## Stop Use & Product Recall

### 3M™ PROTECTA® Cobra Rope Grab AC202D

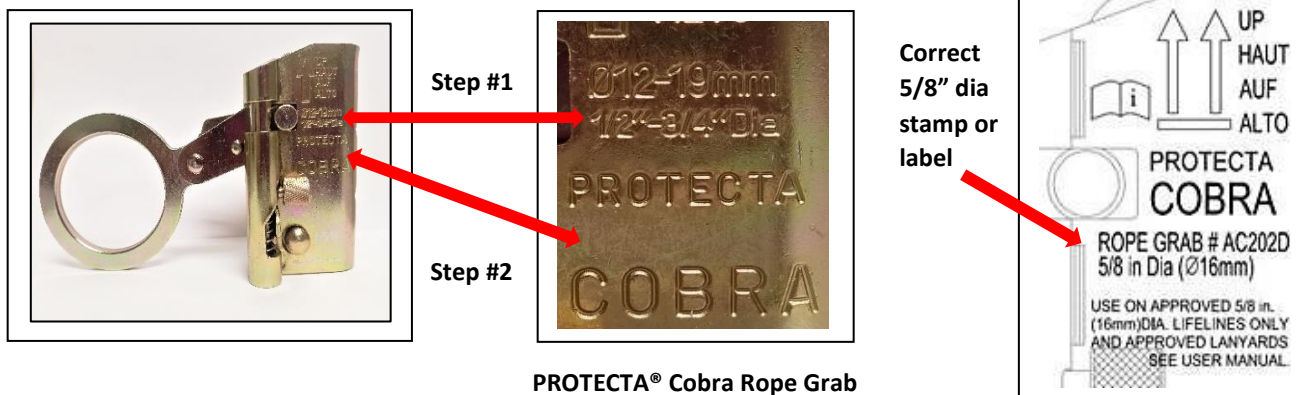
3M Fall Protection has determined that the 3M™ PROTECTA® Cobra Mobile/Manual Rope Grab AC202D is incorrectly stamped for use with 1/2 to 3/4 inch diameter rope on the exterior body of the unit. This Cobra Rope Grab is certified for use **ONLY** with 5/8 inch diameter polyester or polypropylene rope. All marketing information and the Instructions for Use (IFU) for this rope grab correctly identify the size of rope to be used as 5/8 inch polyester/polypropylene rope.

Step 1: Verify the rope diameter is stamped **1/2"—3/4" Dia** on the front side of the unit

Step 2: Verify the rope grab is stamped **PROTECTA COBRA** on the front side of the unit

**Note:** If the unit is stamped 5/8 inch diameter **OR** if the unit has a white label showing 5/8 inch diameter, then the unit is safe to return to normal use (see image on right for correct 5/8" diameter marking).

If the information in Step 1 and Step 2 is stamped onto the side of the rope grab as illustrated above, remove the unit from service immediately. Owners of AC202D Cobra Rope Grabs can choose one of the following options for each affected rope grab they own:

**In the event of a fall from height, a Cobra Rope Grab used with 1/2 inch diameter rope may not arrest the fall and could result in serious injury or death to the worker.** To remedy this situation, 3M is launching a Stop Use & Product Recall to replace all AC202D and related Cobra Rope Grabs that are stamped 1/2"—3/4" Dia.

1. A free, new, properly marked replacement AC202D Cobra Rope Grab; or
2. A check for \$100.
